NAME: FITTING – HULL BULKD & UPPER STRUT – FORGING

J 28B5503

CONSOLIDATED AIRCRAFT CORP. SAN DIEGO, CALIF.

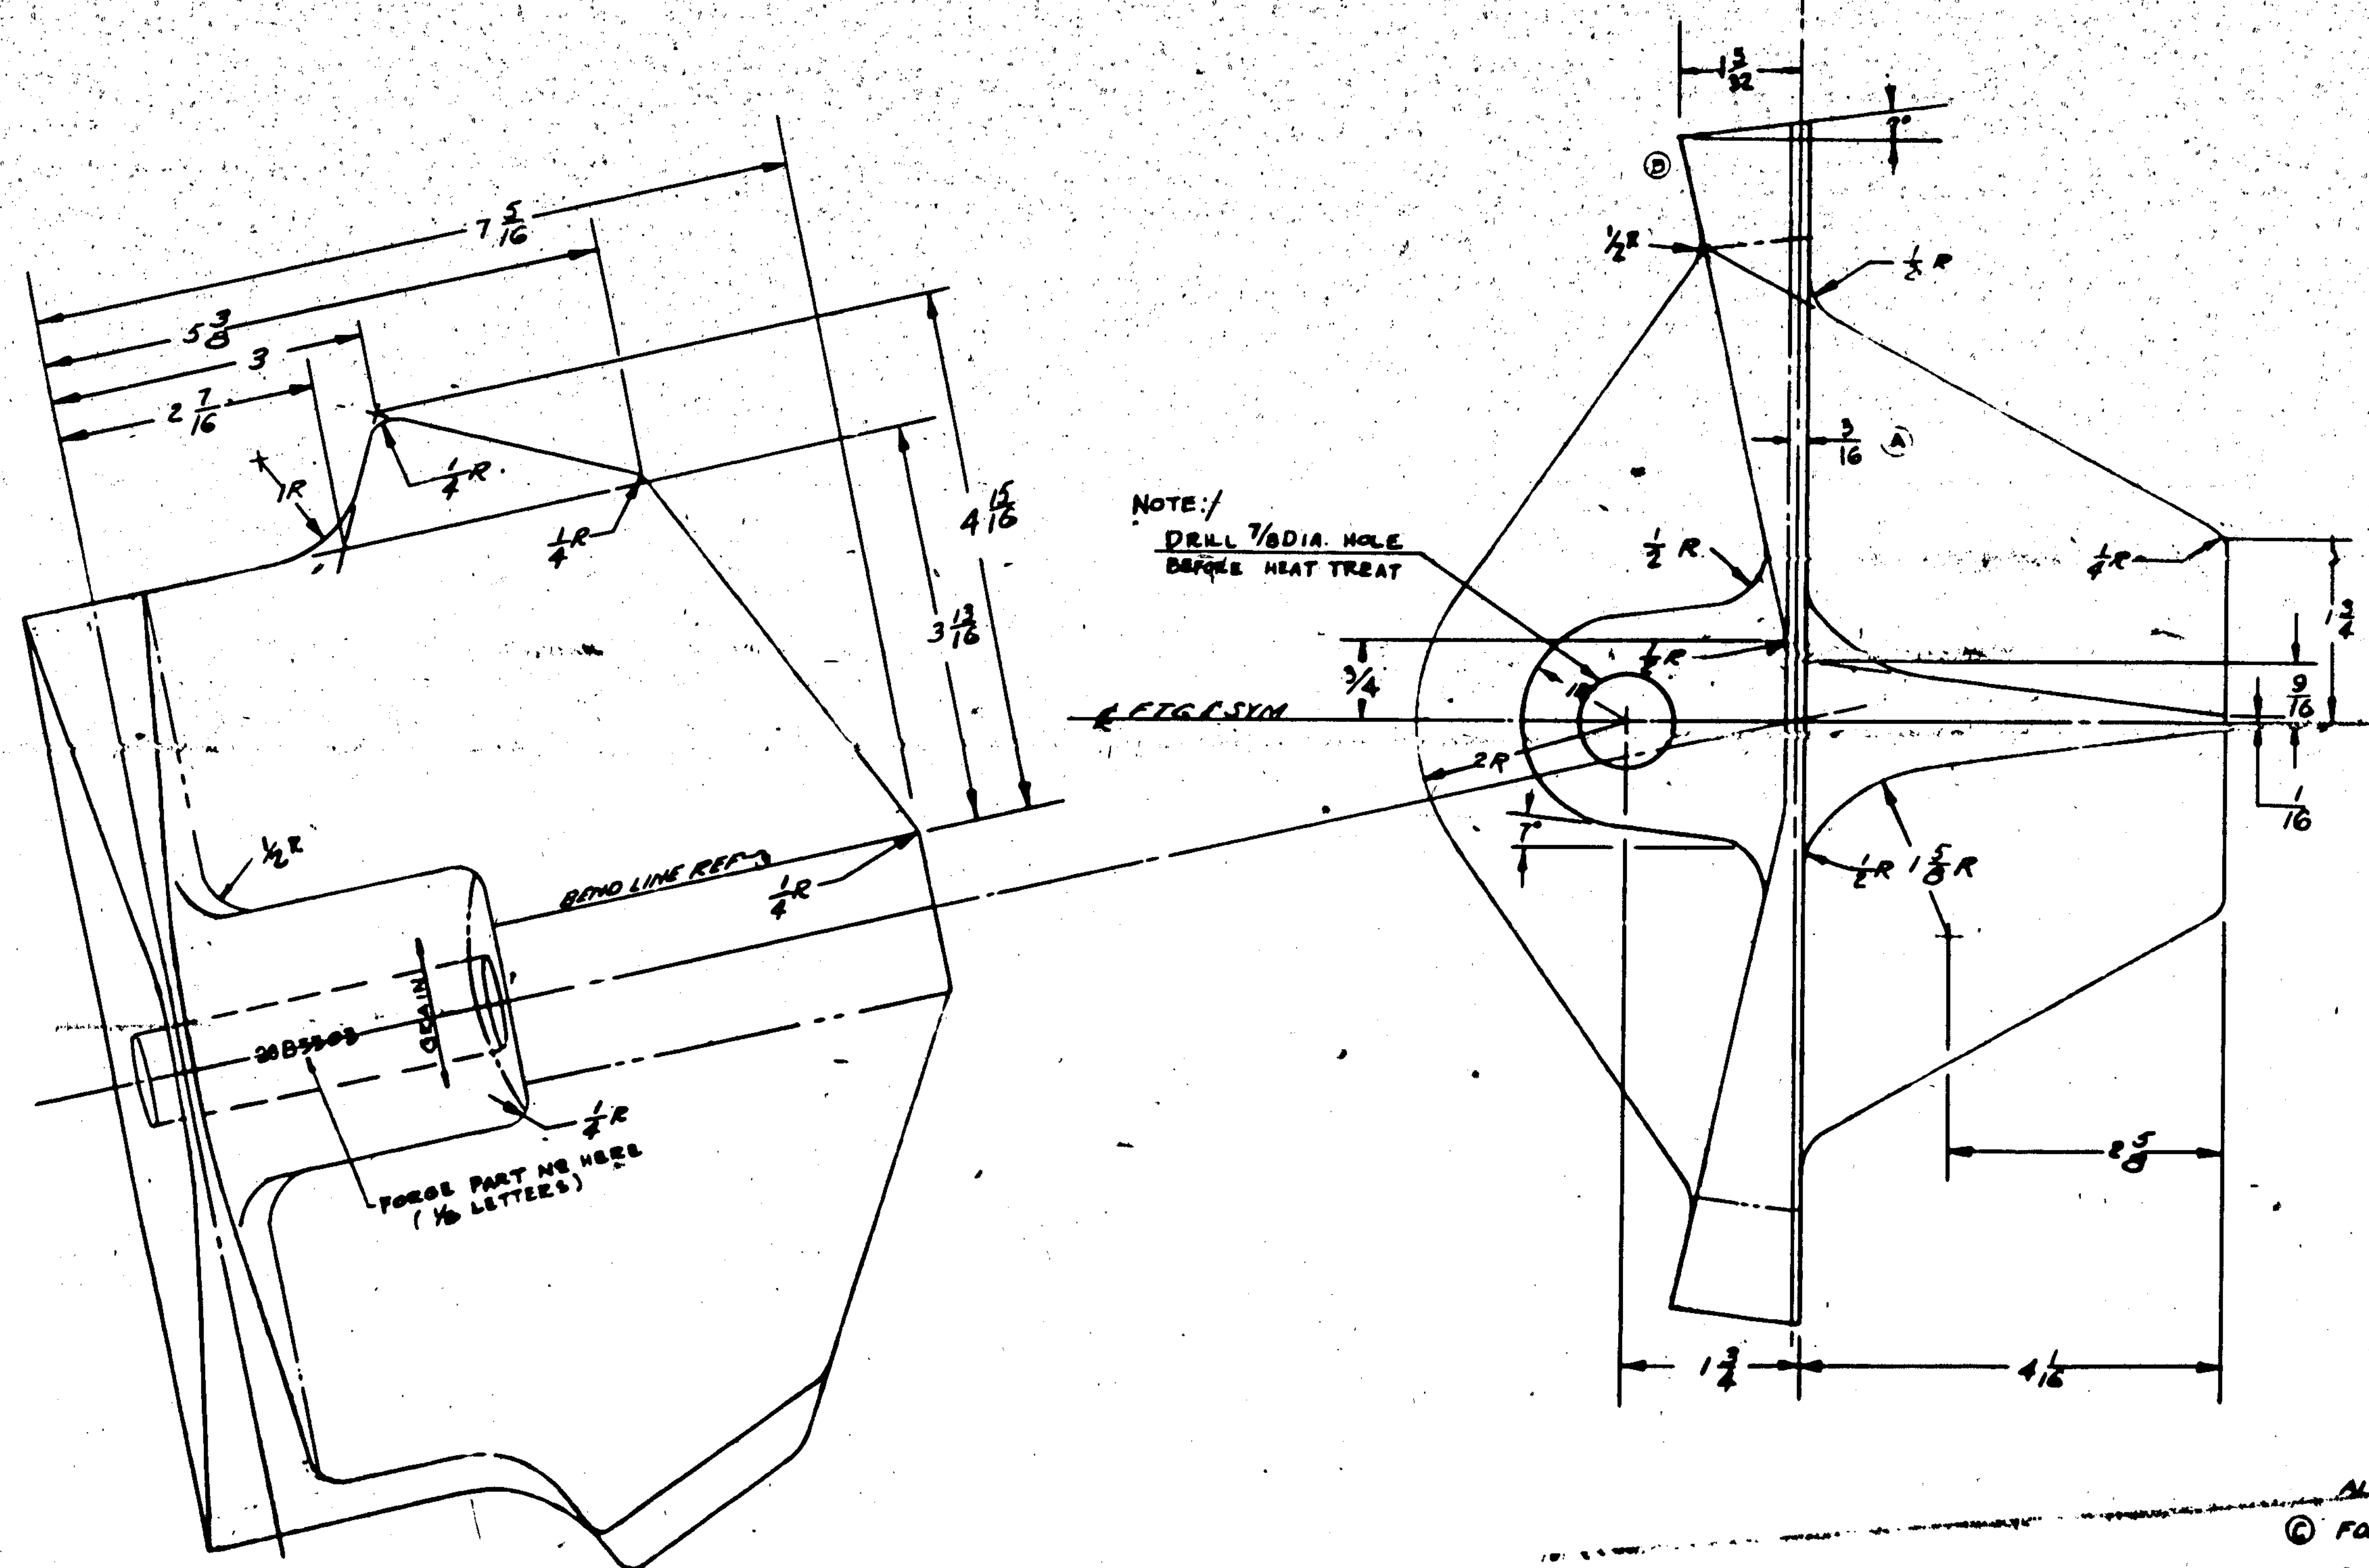
LET	ALTERATION	DATE	BY
A	RADII & THICKNESS CHG'D. FROM RAT 1/2 & 1/8 TO 3/16	[illegible]	[illegible]
B	FLANGE INCREASED		
C	CHG TOL [illegible]	[illegible]	[illegible]
D	ADDED NOTE "X4130 ------ ALTERNATE" WT. CHG NEG.	[illegible]	[illegible]
